National Committee on Uniform Traffic Control Devices

National Committee on Uniform Traffic Control Devices (NCUTCD) Recommended Changes to Proposed Text for 11th Edition of the MUTCD Docket Number: FHWA-2020-0001

- 1 **Federal Register Item Number:** 185 to 227, 647
2 **NPA MUTCD Section Number:** 2E.01 to 2E.59, Appendix A1
3 **Legend:** Base text shown in proposal is the NPA “clean” proposed text.
4 • [NCUTCD recommendation for text to be added in final rule.](#)
5 • [NCUTCD recommendation for text to be deleted in final rule.](#)
6 • [NCUTCD recommendation for text to be moved/relocated in final rule.](#)
7 • [NPA text that was not previously approved by NCUTCD but is now approved.](#)
8 • Explanatory note: [Note that explains purpose of recommended change.]

Figure 2E-XX Example of Guide Signing for a Narrow Gore at an Exit with an Option Lane

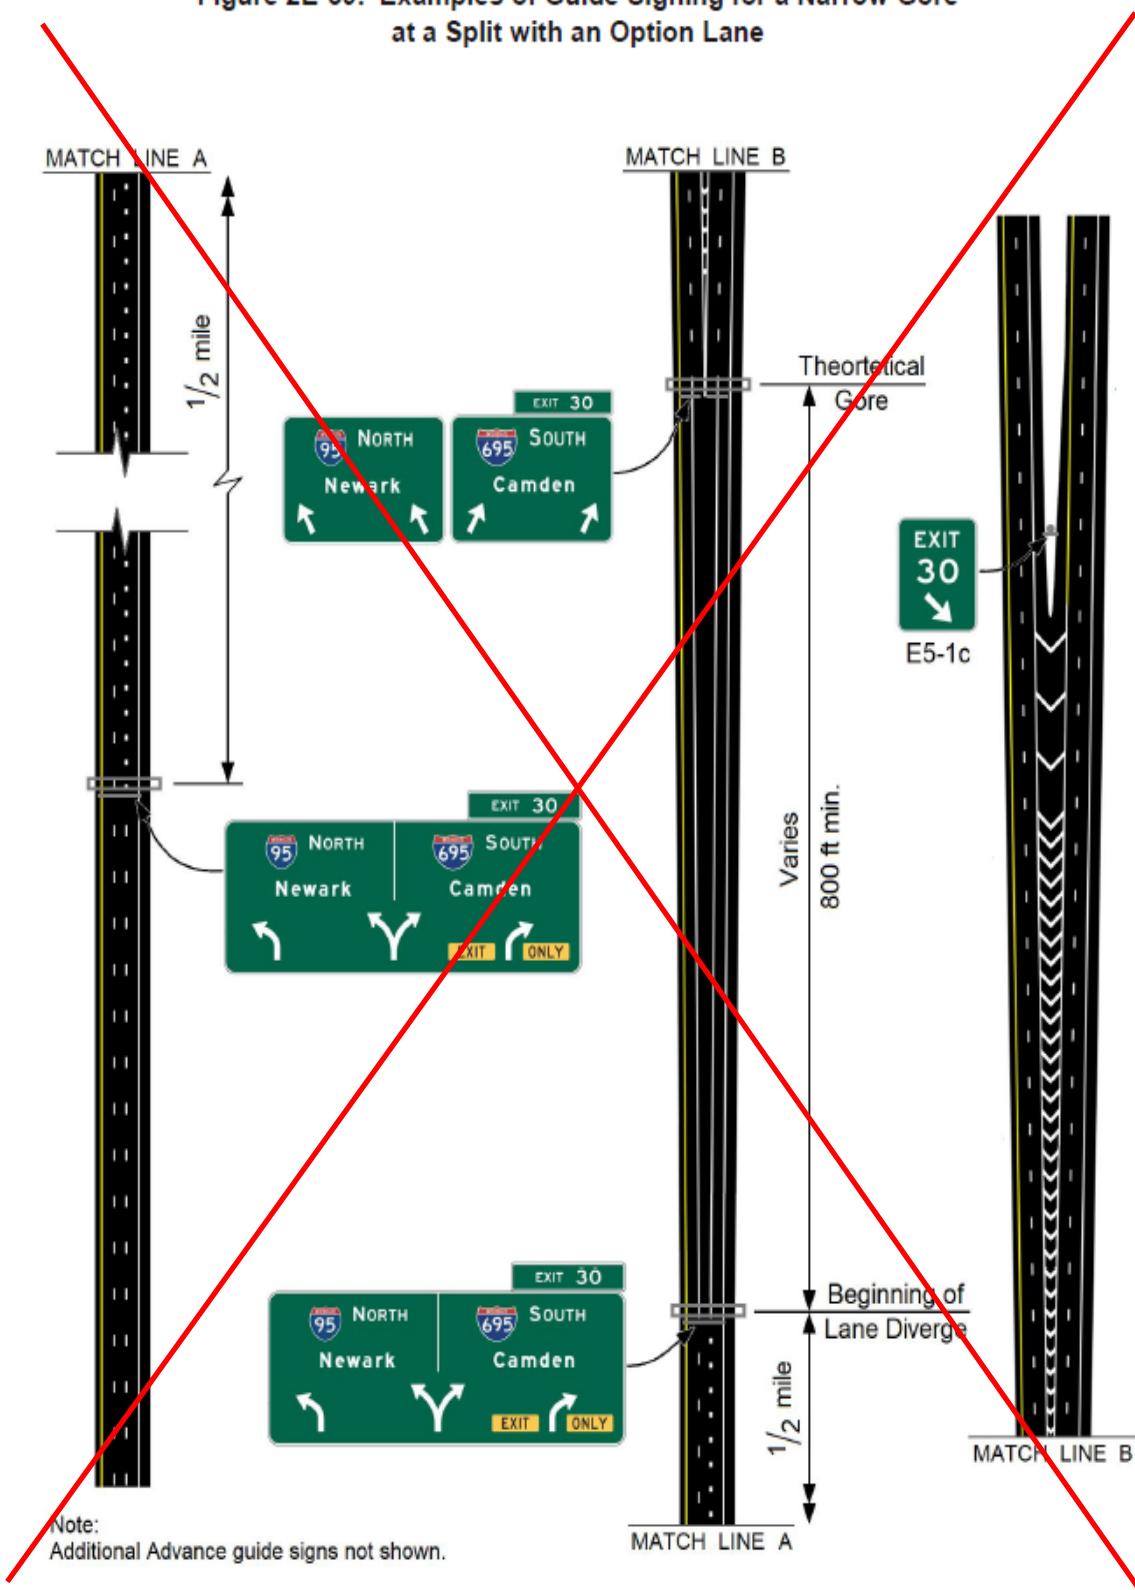
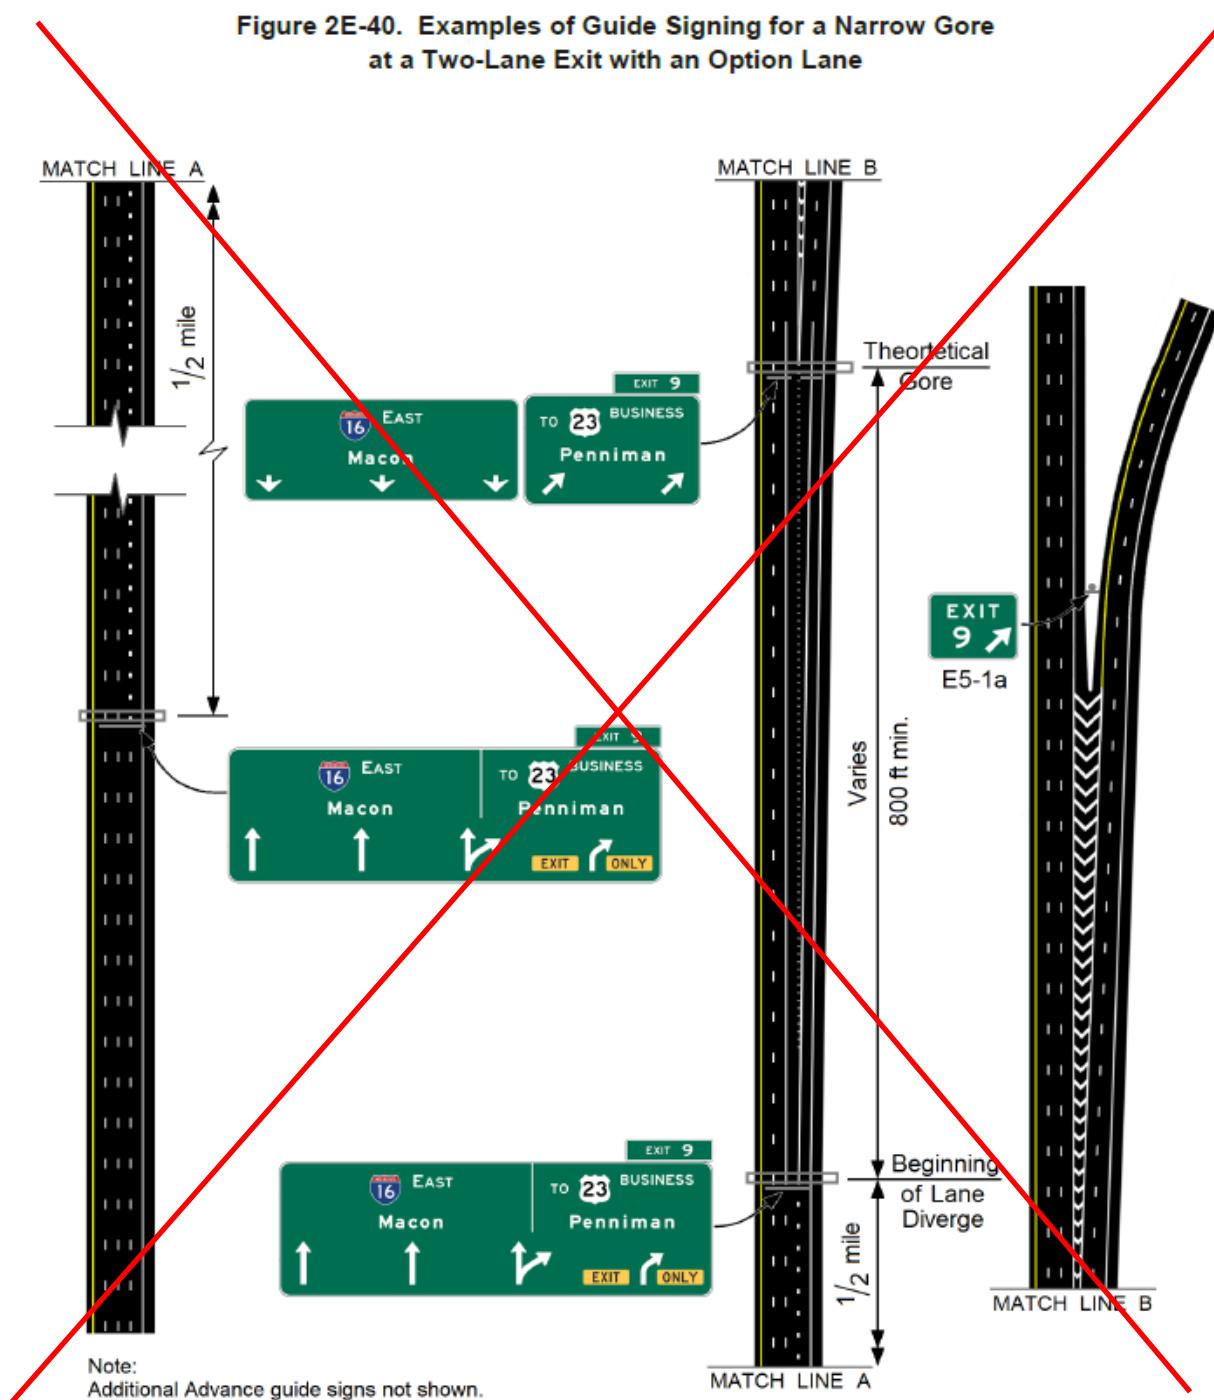
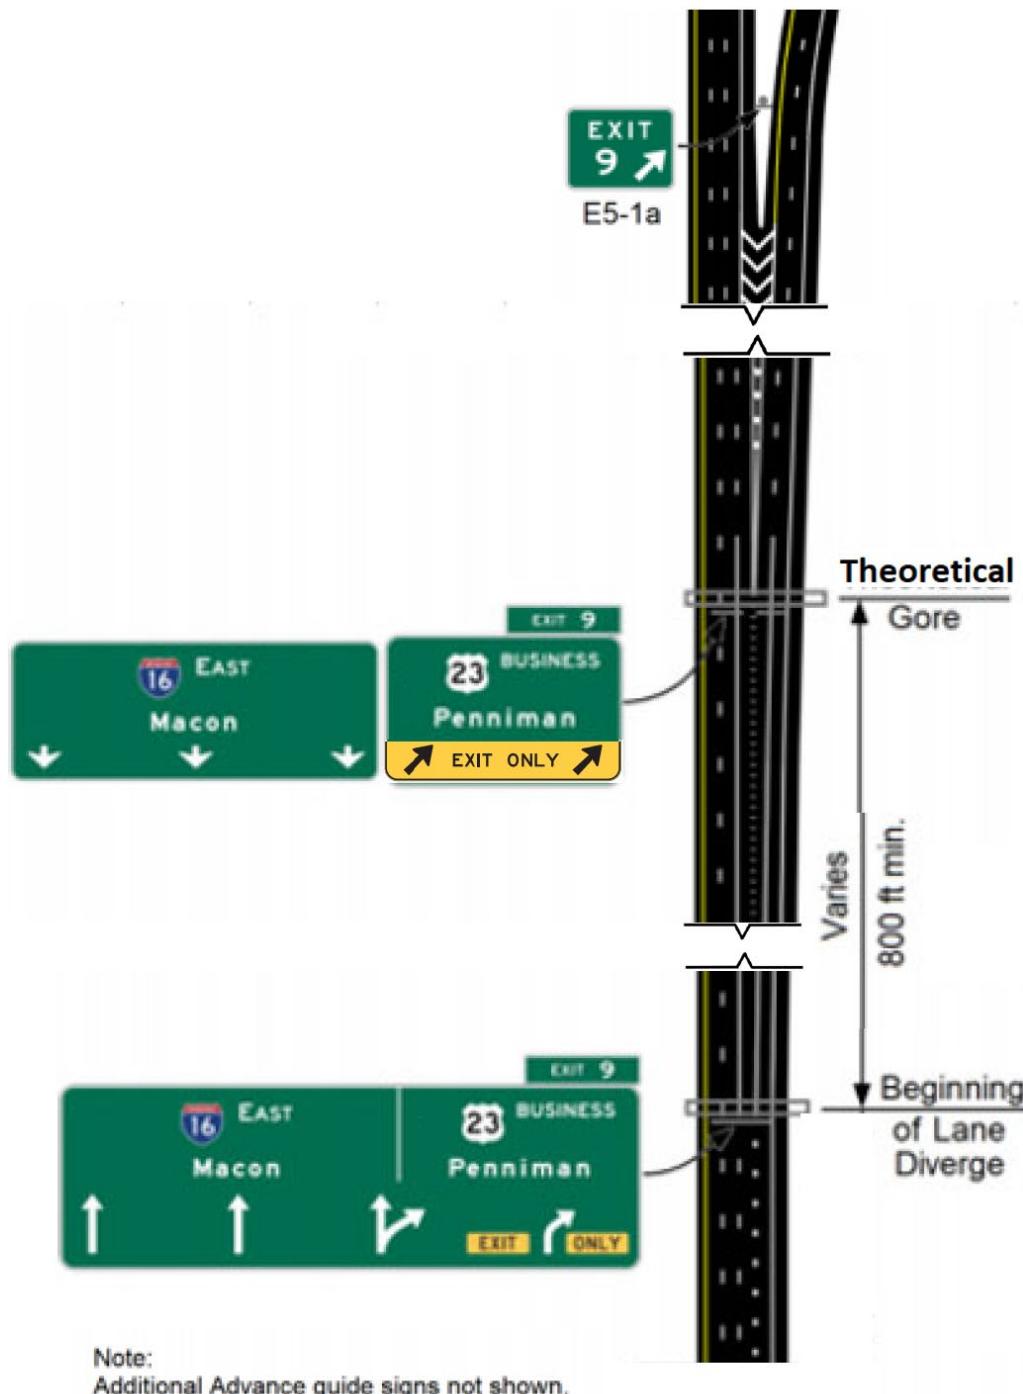
2352 NCUTCD recommends adding a new Figure 2E-39 without the problems inherent in the NPA
2353 figures.

Figure 2E-46. Example of Signing for a Two-Lane Intermediate or Minor Interchange Exit with an Option Lane and a Dropped Lane using Partial-Width Overhead Arrow-Per-Lane signs

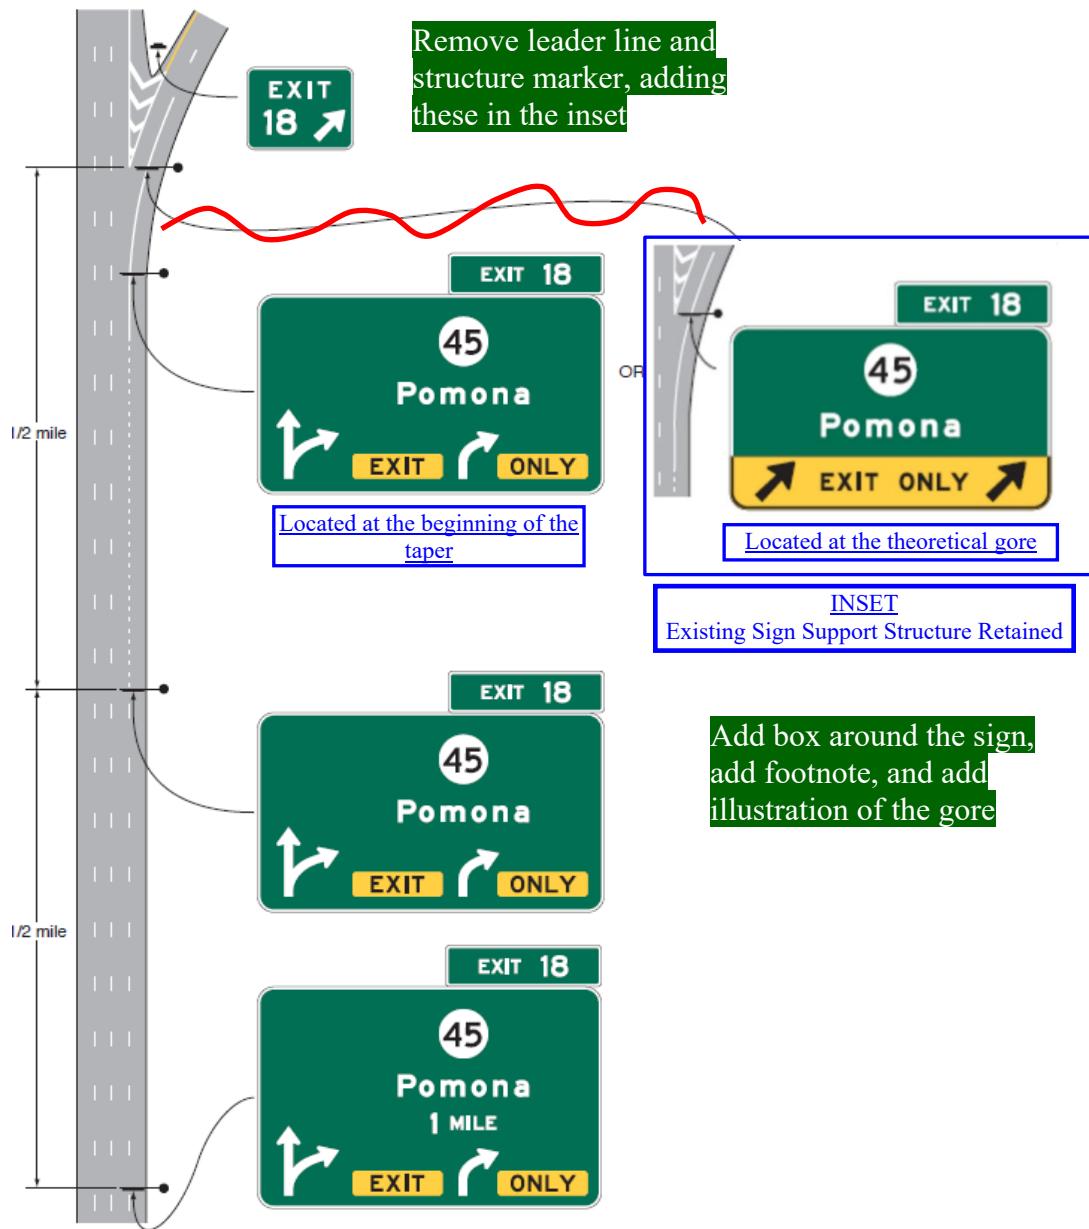
2566 NCUTCD generally agrees with Figure 2E-46 as presented in the NPA, but recommends revising
2567 the alternative for “existing sign structure retained” to use an inset box instead of depicting on
2568 the same figure as the APL sign to improve clarity and reduce confusion.
2569

Figure 2E-50. Example of Sign Spreading

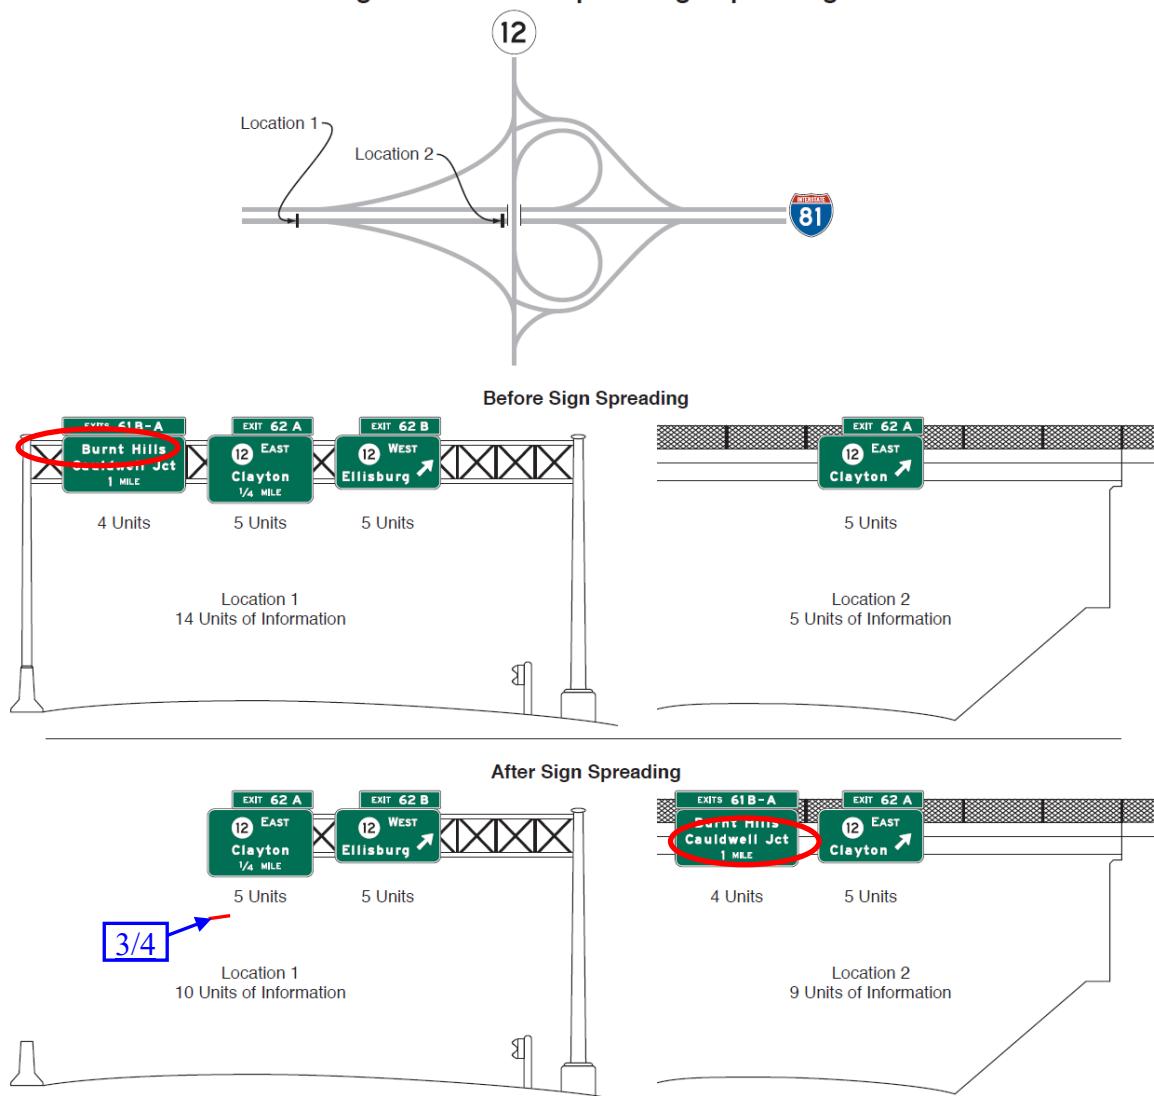
2636
2637 NCUTCD generally agrees with Figure 2E-50 as presented in the NPA, but recommends
2638 reducing the width of the full-width exit number plaques and revising the distance on one sign.
2639

Figure 2E-YY. Examples of Use of a Community Interchanges Sign and a Next Exit Sign

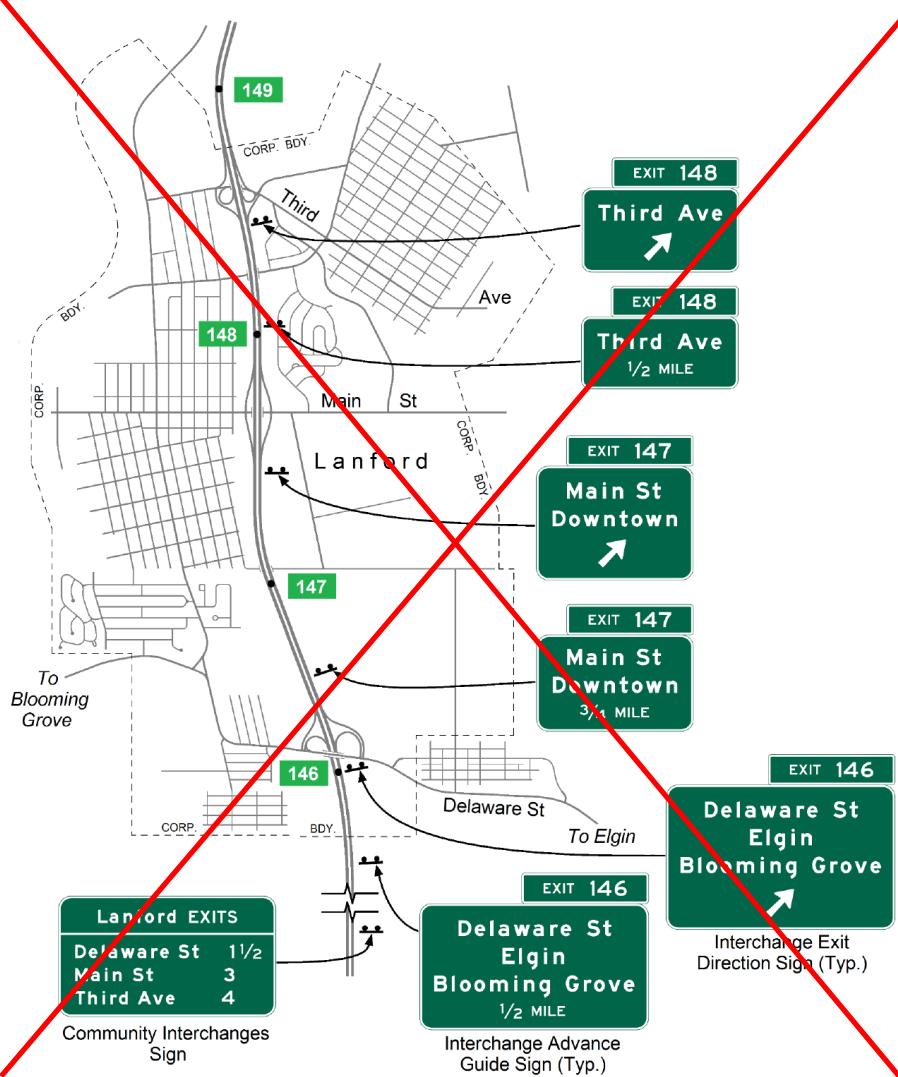
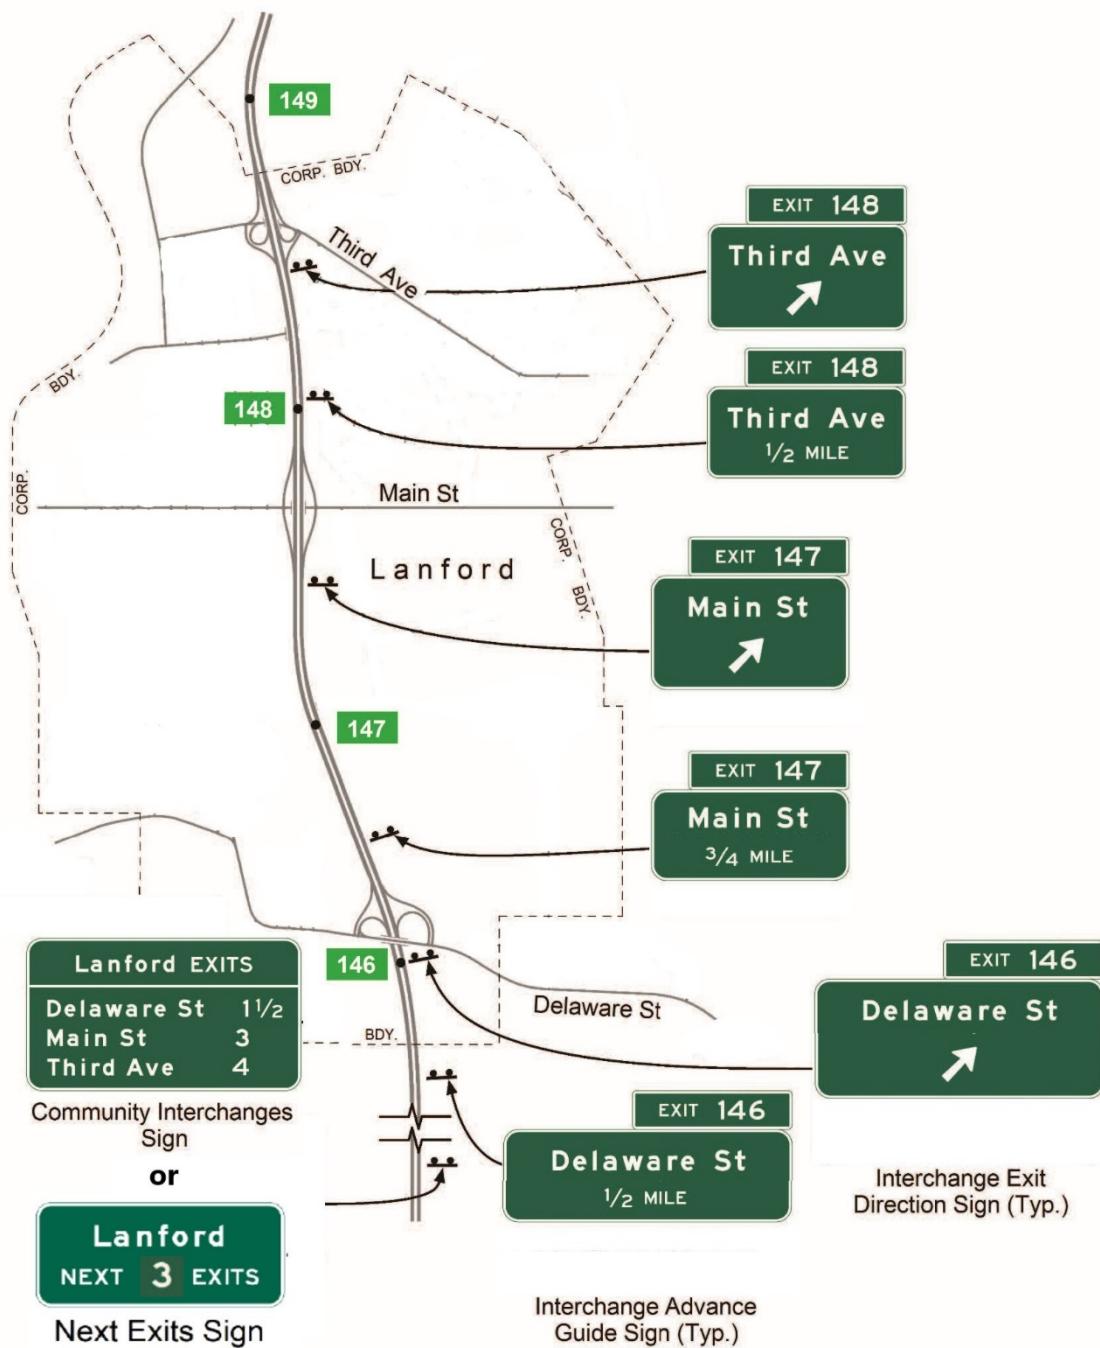
3040 NCUTCD recommends deleting Figure 2E-58 as presented in the NPA and replacing with a new
3041 figure. [REDACTED]

3042 Problems with Figure 2E-58 as presented in the NPA:
